HISTORIC AND DESIGN REVIEW COMMISSION

HDRC CASE NO: 2018-142
ADDRESS: 1115 NOLAN
LEGAL DESCRIPTION: NCB 1665 BLK 1 17 & W 25 FT OF 16
ZONING: R-6 CD, H
CITY COUNCIL DIST.: 2
DISTRICT: Dignowity Hill Historic District
APPLICANT: Chris and Lauren Mongeon
OWNER: Chris and Lauren Mongeon
TYPE OF WORK: Amend previous COA - Request fiberglass columns
APPLICATION RECEIVED: March 16, 2018
60-DAY REVIEW: May 15, 2018
REQUEST:

The applicant is requesting a Certificate of Appropriateness for approval to amend a previously approved design to include the following:

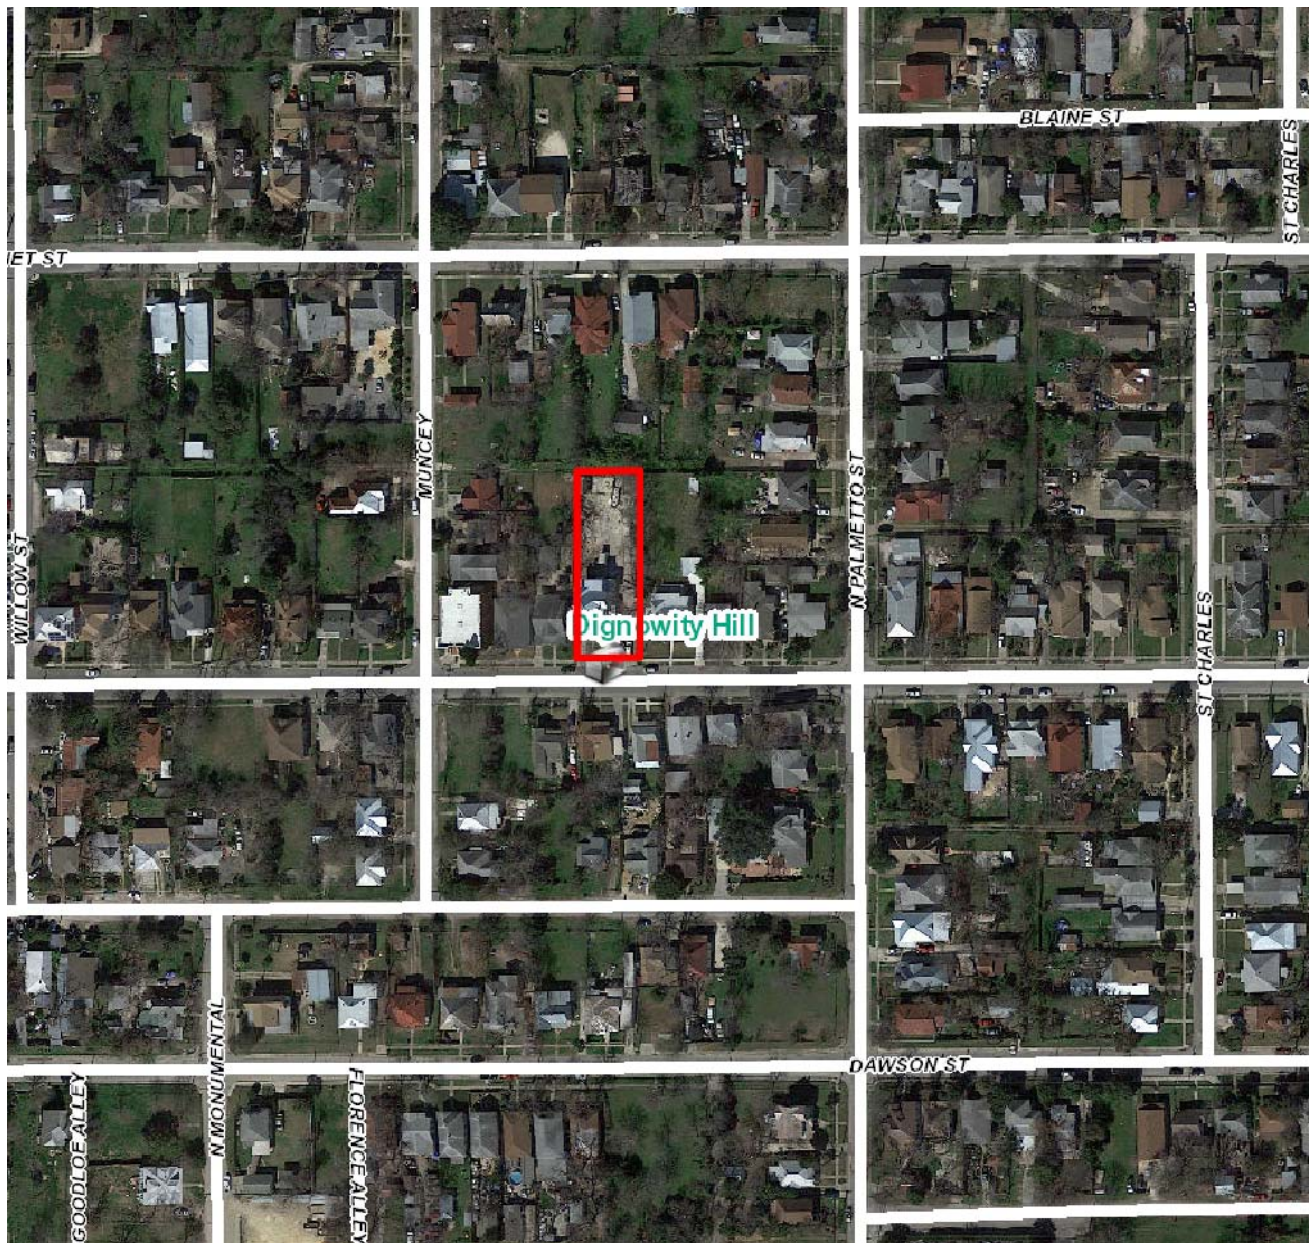
- a. The structure at 1115 Nolan was constructed circa 1910 and features a partial double height porch, a wraparound porch on the first level, ornate bracket work, a front facing porch roof gable and a brick chimney.

- b. The applicant received approval for the removal of the existing wrought iron columns and to install ionic wood columns and capitals at the December 21, 2016, Historic and Design Review Commission hearing. These installations have not occurred and the wrought iron columns and plain wood box capitals remain on the structure. The applicant is now requesting to amend the previously approved design to include fiberglass ionic columns and capitals instead of the previously approved wood columns with the same profile and dimensions.

- c. **COLUMNS** – Per the Guidelines for Architectural Features 7.B.iii, porches, balconies, porte-cocheres, and related elements such as ceilings, floors, and columns should be replaced in-kind when such features are deteriorated beyond repair. When in-kind replacement is not feasible, the design should be compatible in scale, massing, and detail while materials should match in color, texture, and dimensions, and finish. Staff finds that the proposal to amend the previous approval for wood columns to allow for fiberglass columns and capitals with the same profile and dimensions is consistent with the Guidelines.

Staff recommends approval as proposed based on finding b and c.
